**Central Queensland Coal Project**  
**Chapter 3 - Project Changes and**  
**Responses to Regulator Comments**

**Central Queensland Coal**

**CQC SEIS, Version 3**

**October 2020**

**Figure 3-9: Ground-truthed regional ecosystems**

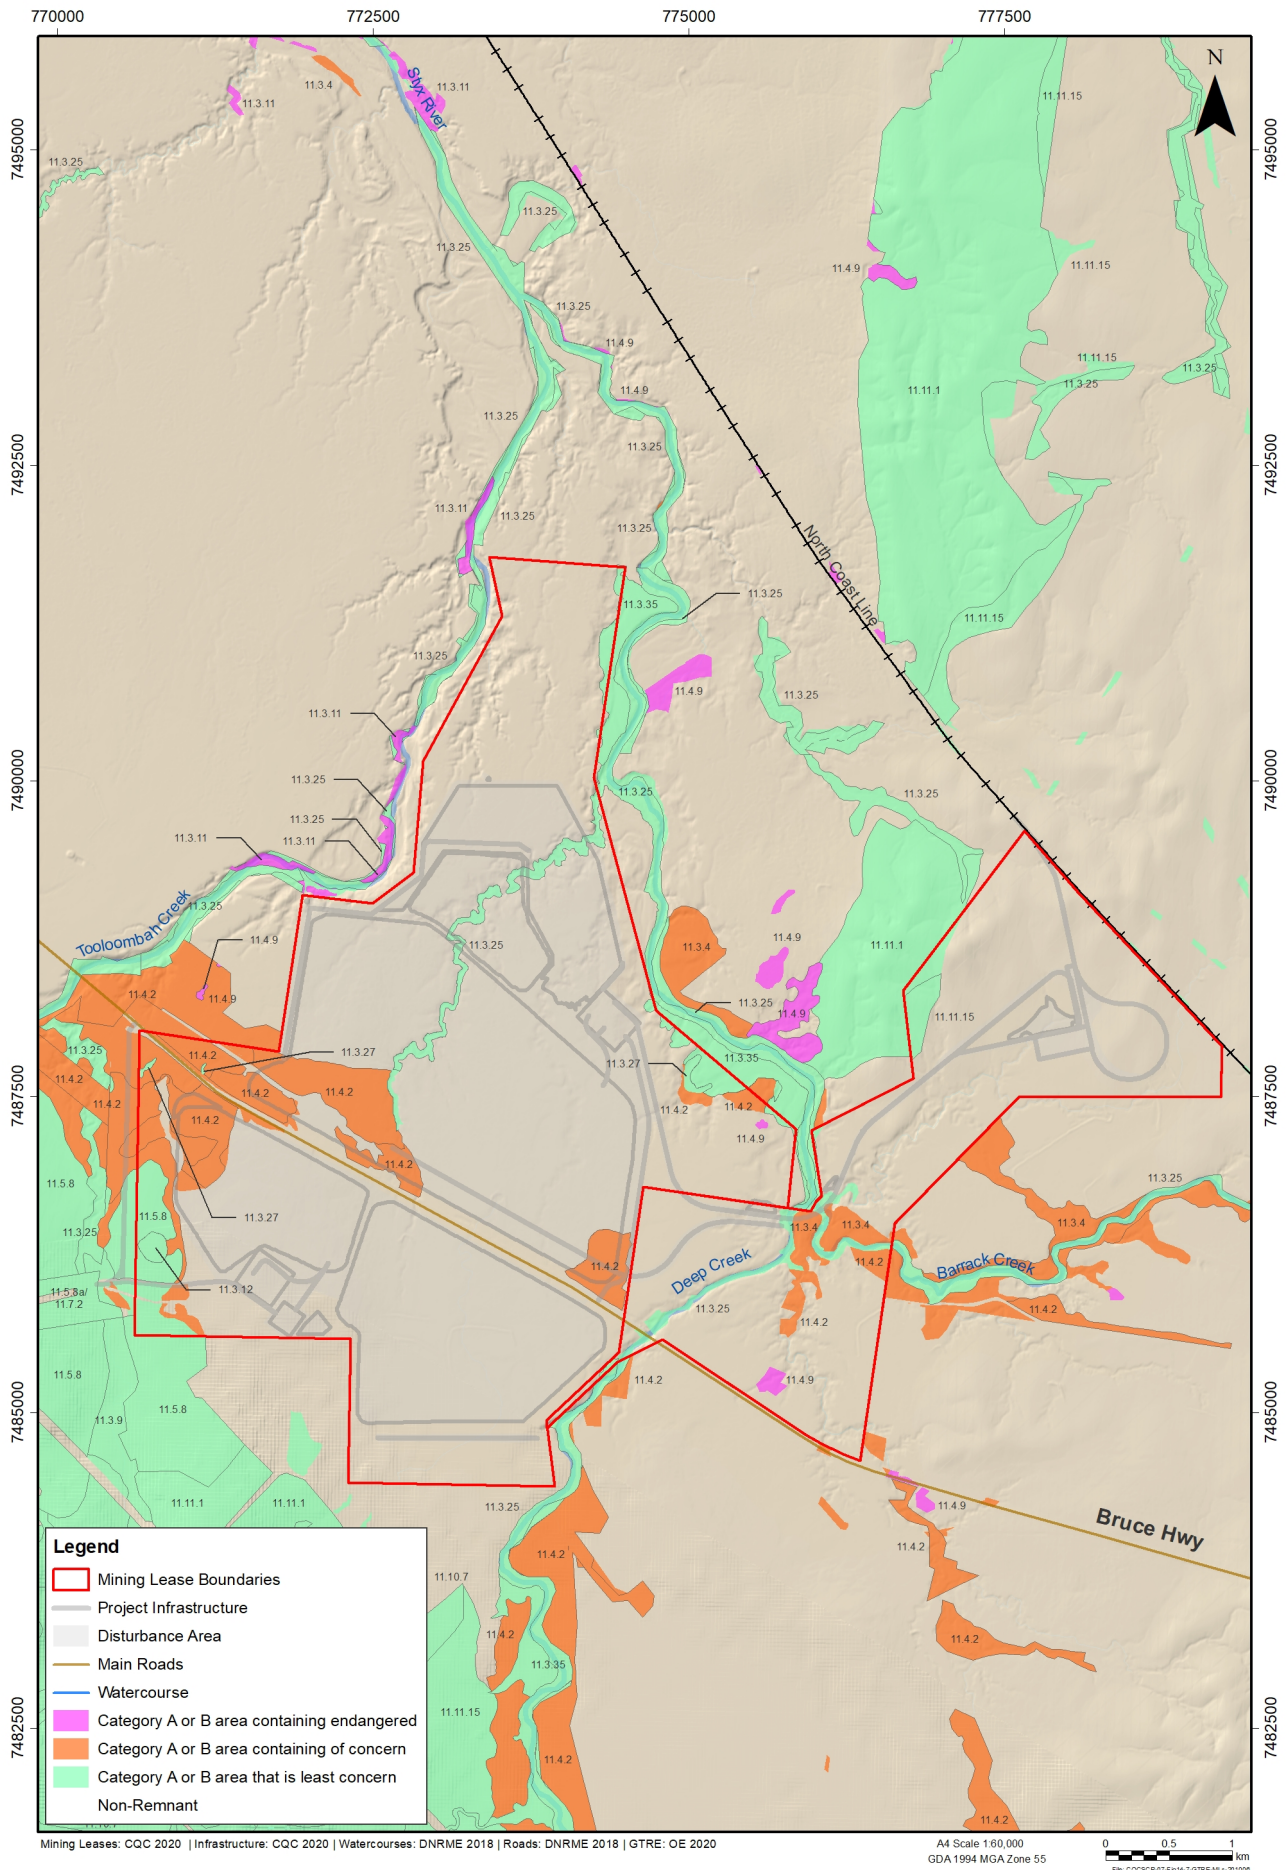
The recommendation on the last submission requested that the amended EIS provide further justification on the adequacy of the extent and location of flora surveys, noting that in "Figure 14-1" they seem inadequate. It appears that a different "Figure 14-1" has been inserted in the revised chapter which has the same survey locations overlaying vegetation that has been categorised in a different way. Further explanation of why these site locations are adequate has not been provided.

Provide a justification that the location and extent of the survey sites is adequate in areas mapped as "of concern" remnant vegetation. Additionally replace "Figure 1" with the amended map (Appendix 19) which classifies where the "of concern" remnant vegetation is, alongside the endangered and least concern vegetation.

Depending on their timing, surveys have been undertaken in accordance with either Neldner et al. (2005), Neldner et al. (2017) or Neldner et al. (2019), or Eyre (2015). Based on the survey events undertaken, Figure 14-6 shows the extent of ground-truthed RE within the Project Site and Near Surrounds, as well as the source of the data, and Figure 14-7 shows the ground-truthed RE present. These figures are replicated in Figure 3-8 and Figure 3-9 below.

Eleven REs were identified within the Project Site during field surveys and a total of 339 ha of remnant vegetation was mapped. Figure 14-6 and Figure 14-7 are replicated in Figure 3-8 and Figure 3-9, respectively. The ground-truthed RE mapping is now presented consistently throughout SEIS v3.

Figure 3-10: Location of fauna surveys for the Project

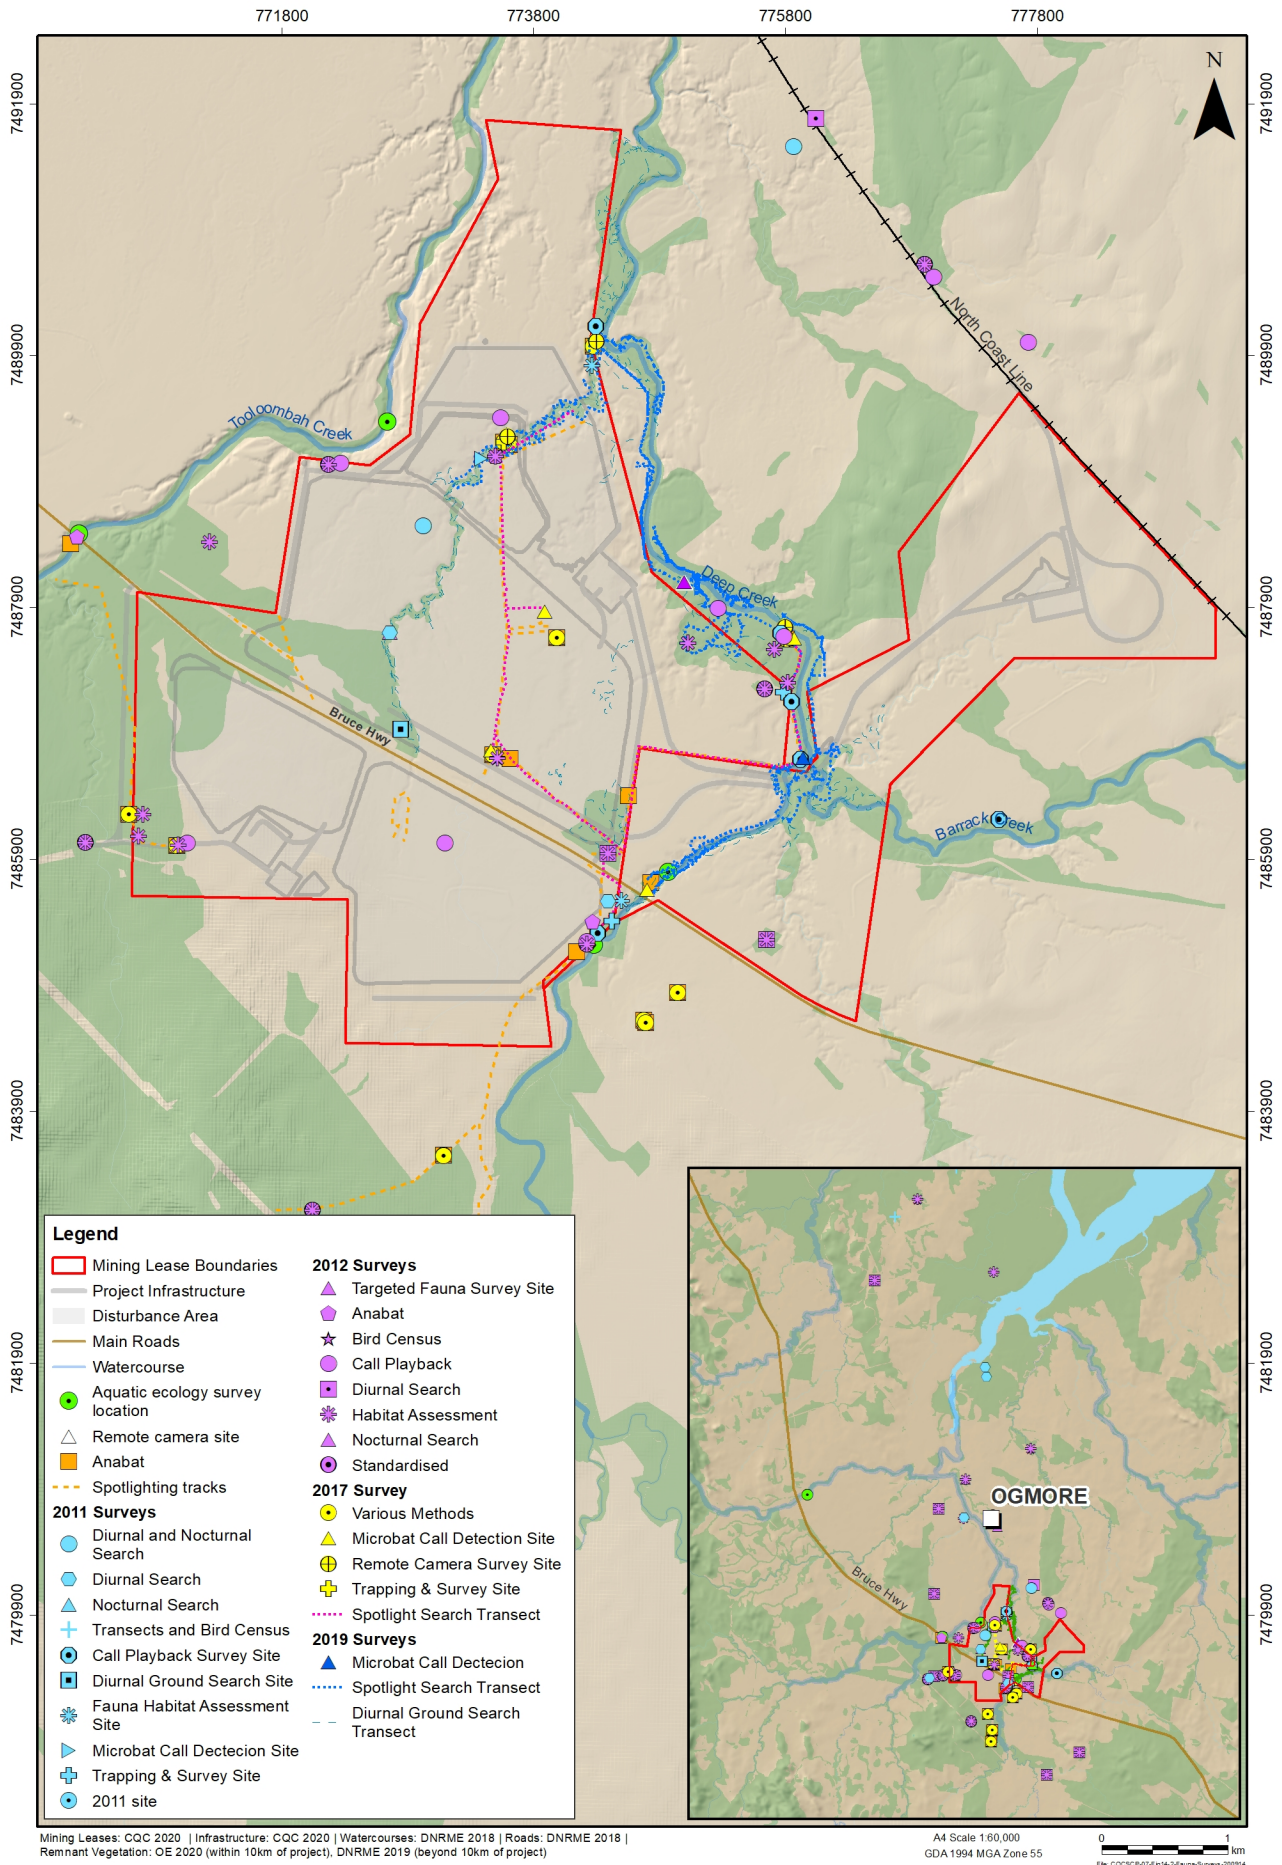
TOR Category or EIS Chapter	Terrestrial Ecology	Submitters Reference to EIS Section (if provided)	Section 14.6.2.1 Chapter 14 Figure 2 Fauna Survey Locations” Pages: 15-16
Submitters Reference (if provided)	Comment 12; Table 1; 32.85

Figure 3-10 illustrates the locations of a variety of fauna survey activities associated with Deep Creek and Near Surrounds which contributed to the EIS and SEIS.

**Figure 3-13: Vegetation potentially impacted by groundwater drawdown and proposed Mamelon offset areas**

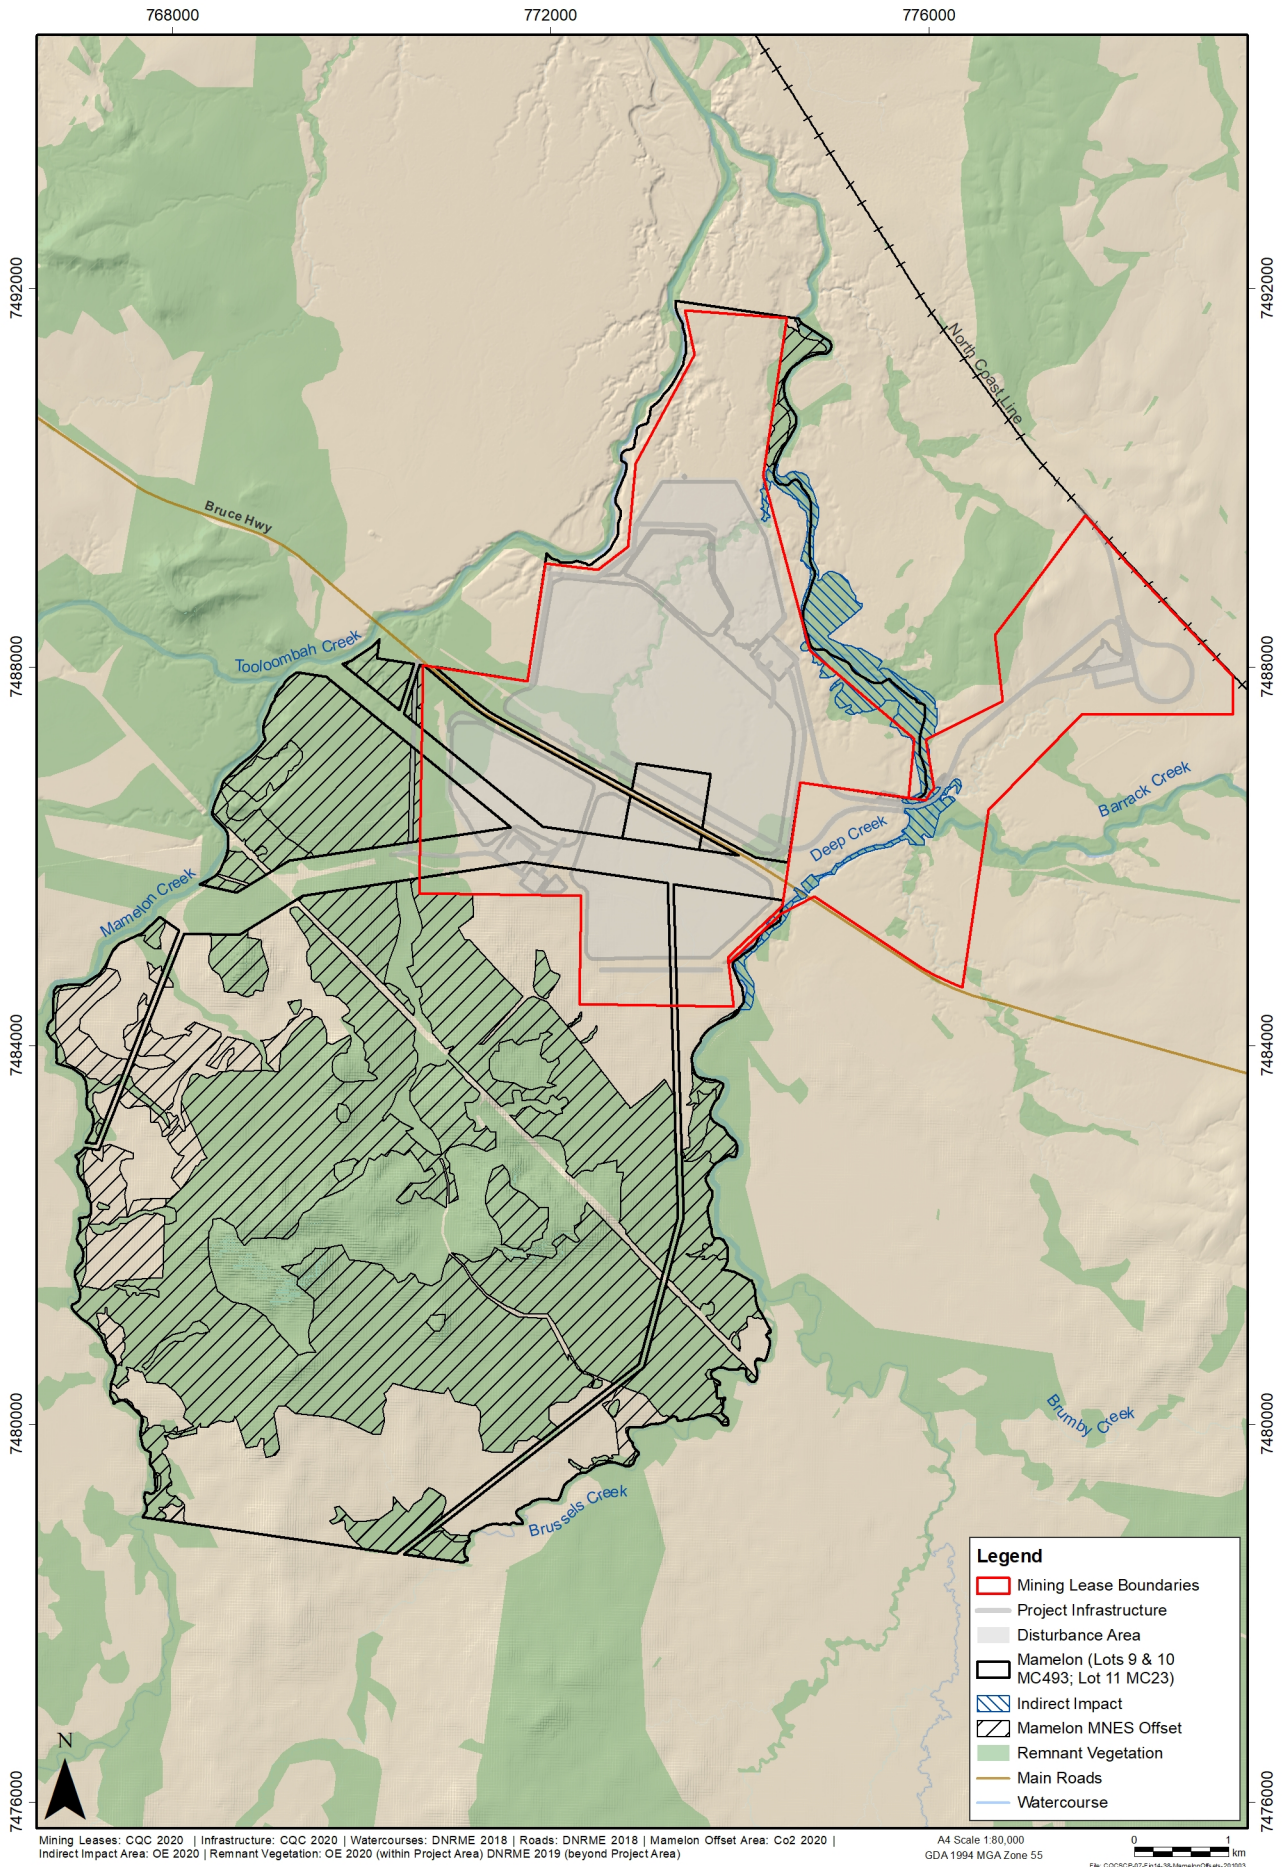
- *the potential for groundwater drawdown impacts on identified Koala and Greater Glider habitat near Deep Creek, south of the Waste Dump Area, as illustrated in Figure 16-18 (p16-140);*
- *the conservation gain of the proposed offsets are not new or additional as the risk of loss for the unaffected habitat is low (i.e. the habitat would not be lost in the future as a result of the proposed mining development); and*
- *the proposed offset areas do not seem to provide connectivity with contiguous habitat in the Southern Brigalow region (Figure 16-23, p16-207).*

As shown in Figure 3-13, the 165.23 ha of vegetation that may be affected by groundwater drawdown has been excluded from the Mamelon offset areas.
